The Secretary
NSW Department of Planning, Industry and Environment

26 February 2021

I refer to the Department's letter of 14 January 2021 regarding State Significant Development SSD 3846 West Culburra Mixed Use Subdivision regarding the amended plans arising from Sealark Pty Ltd v Independent Planning Commission – West Culburra Concept Proposal Land and Environment Court Proceedings No 2019/78149 for land north of Culburra Road and west of the Culburra Beach township (Part Lot 5 & Part Lot 6 of DP 1065111 and Part Lot 1 DP 631825) in the Shoalhaven City Local Government Area (LGA). Submissions need to be made to the Department by 26 February 2021.

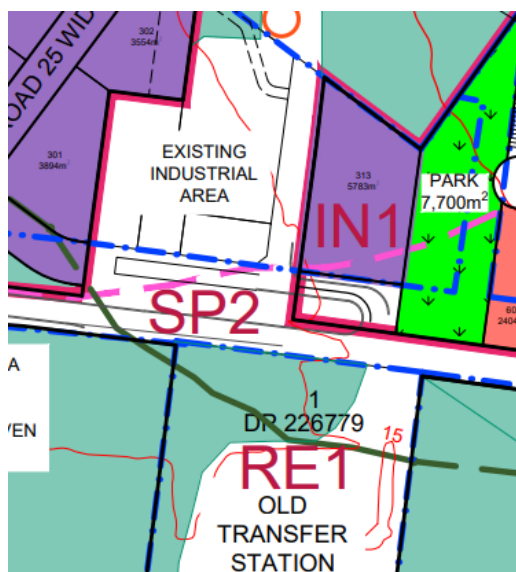
As shown in the below site plans from Endeavour Energy's G/Net master facility model (and extracts from Google Maps Street View) the main features of the electricity infrastructure over the land are:

- An easement benefitting Endeavour Energy (indicated by red hatching) over the Culburra Treatment Works site for 11,000 volt / 11 kilovolt (kV) high voltage overhead power lines and a pole mounted substation (indicated by the symbol ).
- Low voltage and 11 kV high voltage underground overhead power lines with pole mounted substations to the road verges / roadways.

Appendix 1 Concept Plan

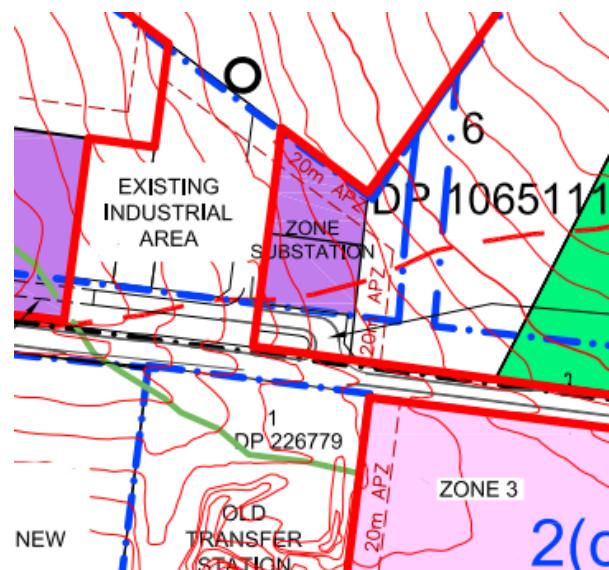
However, in the interim provision for a new zone substation and supply line still needs to be made. In this regard the updated Concept Plan no longer shows 'Zone Substation' on Industrial Land Lot 313 (5783 m²) on eastern side of Strathstone Street.
